主旨: Fw: S. 16 Planning Application No. A/YL-KTN/1157 - Departmental Comments

A/YL-KTN/1157

Comments from Drainage Services Department

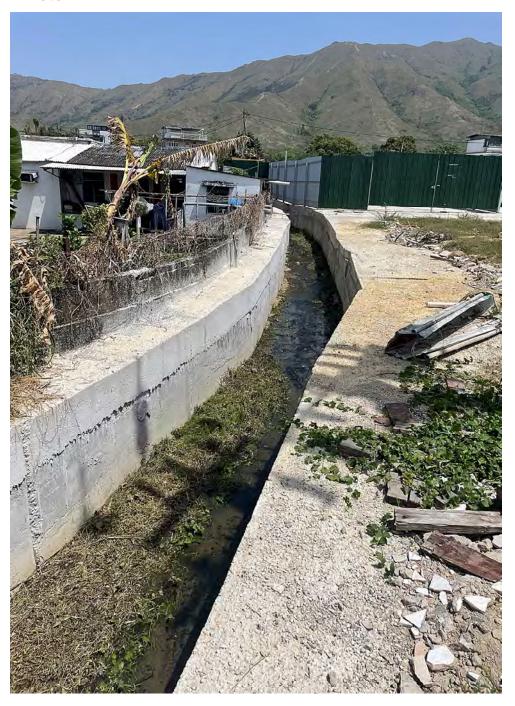
1. The applicant should clarify location of the subject site shown in the marked-up sketch which indicates the proposed discharge path.

The location of the subject site is revised in the marked-up sketch.

Catchment Area Plan for Existing 1.65m(W)x1.2m(D) Open Channel

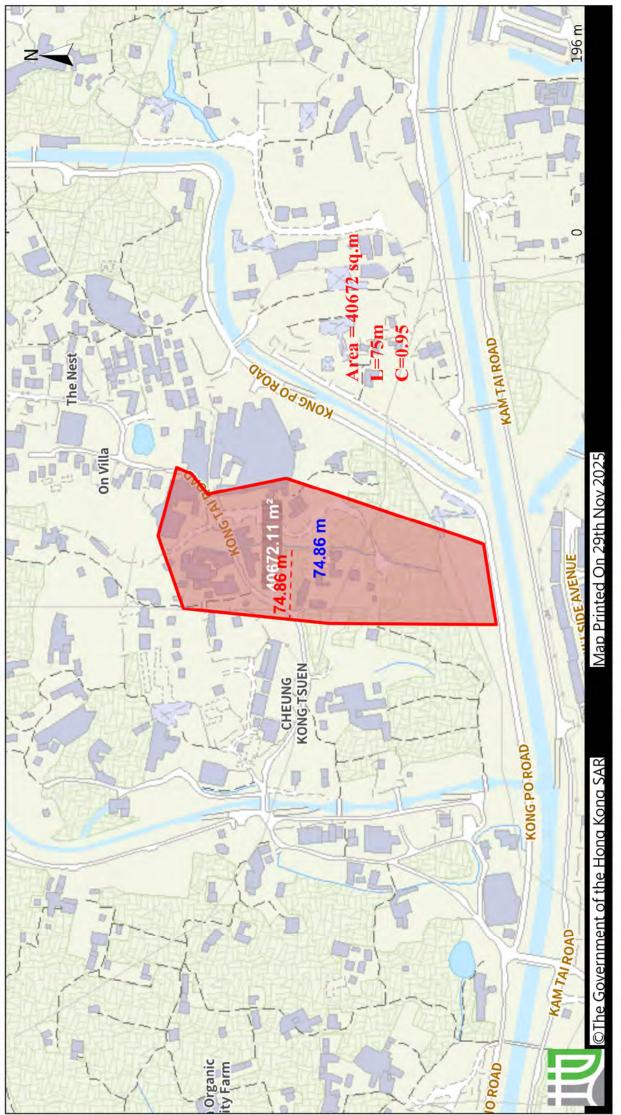
3. Catchment area of the existing open channel at the south of the application site had not been considered in the submission. The applicant should review the hydraulic calculation.

4. Flow velocity of the existing open channel is suggested to be within a range, i.e. 0.75 m/s to 3.0 m/s. The applicant should review the hydraulic calculation.

Catchment area of the existing open channel at the south of the application site has been considered in the submission

Calculation is updated.
